DIGITAL 299 BROADBAND PROJECT

Addendum to Final Environmental Assessment and Initial Study/Mitigated Negative Declaration

April 2024

Figure 1 Proposed Alignment4

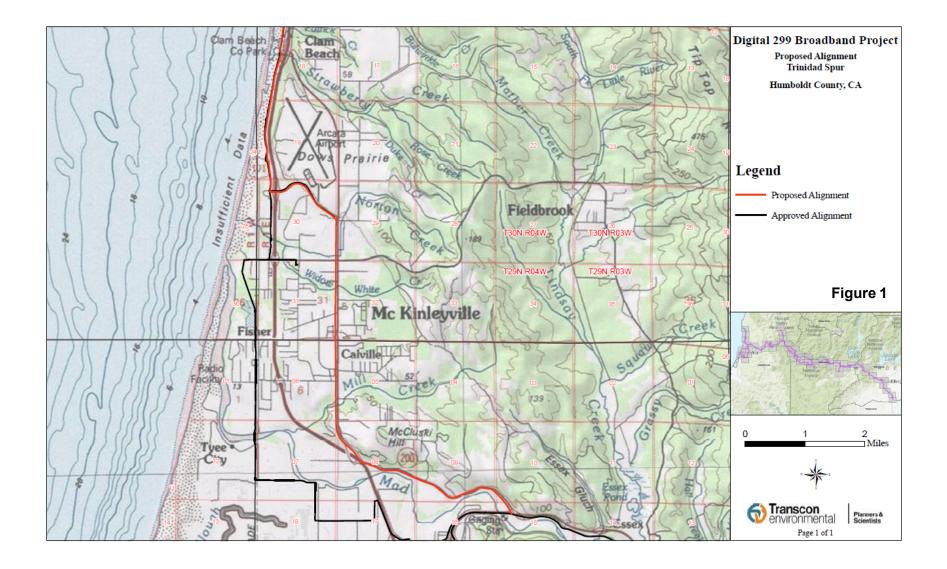
Section 2.21 Project Location and Areas of Disturbance of the EA/ISMND describes the project's action area across Humboldt, Trinity, and Shasta counties. At the northwestern end of the project, the EA/ISMND describes the primary route following local roads in Arcata and along the Hammond Trail. Instead, the Proponent proposes to reroute the alignment to the east, reducing the total mileage of fiber optic conduit by about 2 miles. The Proponent proposes to modify the alignment to head west along State Route (SR) 200 from the intersection with SR-299 to the intersection with Central Avenue, where the alignment will then head north to Airport Road. The

alignment will then head north along U.S. Route 101 until following an on-ramp at Clam Beach Drive, where construction will follow the previously studied alignment, which follows Clam Beach Drive, U.S. Route 101, and other local roads north to the City of Trinidad. This change in the alignment will help the State of California meet their MMBI goals by 2026 by providing future opportunities for last-mile tie-ins in downtown McKinleyville. Additionally, the alignment change will reduce the potential impacts to resources by staying in more developed areas along public right-of-way. Examples of reduced impacts include impacts to public recreation by avoiding construction on the Hammond Trail and impacts to aquatic resources by eliminating one crossing of the Mad River.

The location of the Proposed Modificationis shown in **Figure 1**. The originally proposed alignment that follows Hammond Trail is shown in black on **Figure 1**).
